September 19, 2025

Re: Hydrogeological Assessment Peer Review, 325 King Street, Proposed Hotel Development

Borehole and Monitoring Well and Test Pit Location Plan

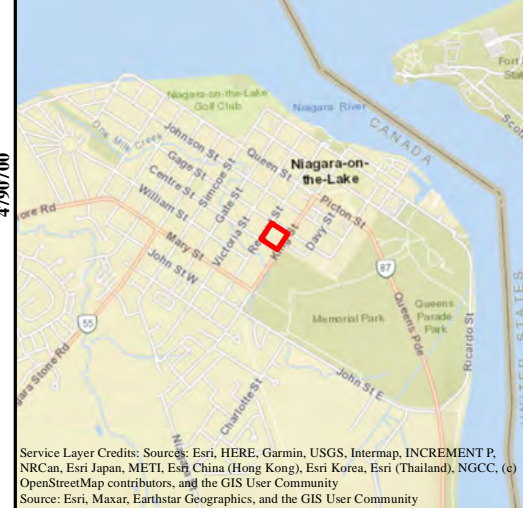
The letter included some general discussion of where a *'permeable sand and gravel layer'* is not present with respect to the proposed building/excavation. With respect to where the *'permeable sand and gravel layer'* is present was stated, *"the east limit of the proposed underground parking level 2"*. We subsequently received on September 19, 2025 a Test Pit Investigation Letter (Soil Engineers Ltd., 2025d) which indicated that at test pits 1A, 2 and 3 *"a sand and gravel layer with an approximate thickness of 0.7 m was contacted at approximately 6.8 m BGS beneath the silt/silty clay units"* (Appendix D).

We have not been provided the expected short-term construction, or long-term post-construction dewatering rates, or zones of influence for construction in the area of P2 and the '*permeable sand and gravel layer*', i.e. near MW3 as shown on the stand-alone "*Borehole and Monitoring Well and Test Pit Location Plan*" (Appendix D). However, in the absence of being provided an updated Hydrogeological Assessment reflecting their investigations of August/September 2025, it is recommended that the Town of Niagara-on-the-Lake require as part of their conditional approval of the development:

- 1) 'Bath-tubbing' in areas of '*permeable sand and gravel*' to prevent long-term on-going dewatering discharge to the Town's stormsewer. Also, if other areas are determined to have sand layers requiring active dewatering these should also be completed with 'bath-tubbing'.
- 2) A settlement monitoring program be completed for at least 200 m from MW3 (Appendix D), unless a smaller radius is determined by the applicant's hydrogeological consultant and calculations provided.
- 3) Daily construction dewatering rates be provided to the Town on a monthly basis including daily total suspended solids values of post-filtered discharge.

It is recommended that the Town consider requiring an updated Hydrogeological Assessment with the items listed in Section 4.1., including requiring a stormsewer capacity study if long-term dewatering discharge is allowed by the Town to the stormsewer rather than requiring limited 'bath-tubbing'.
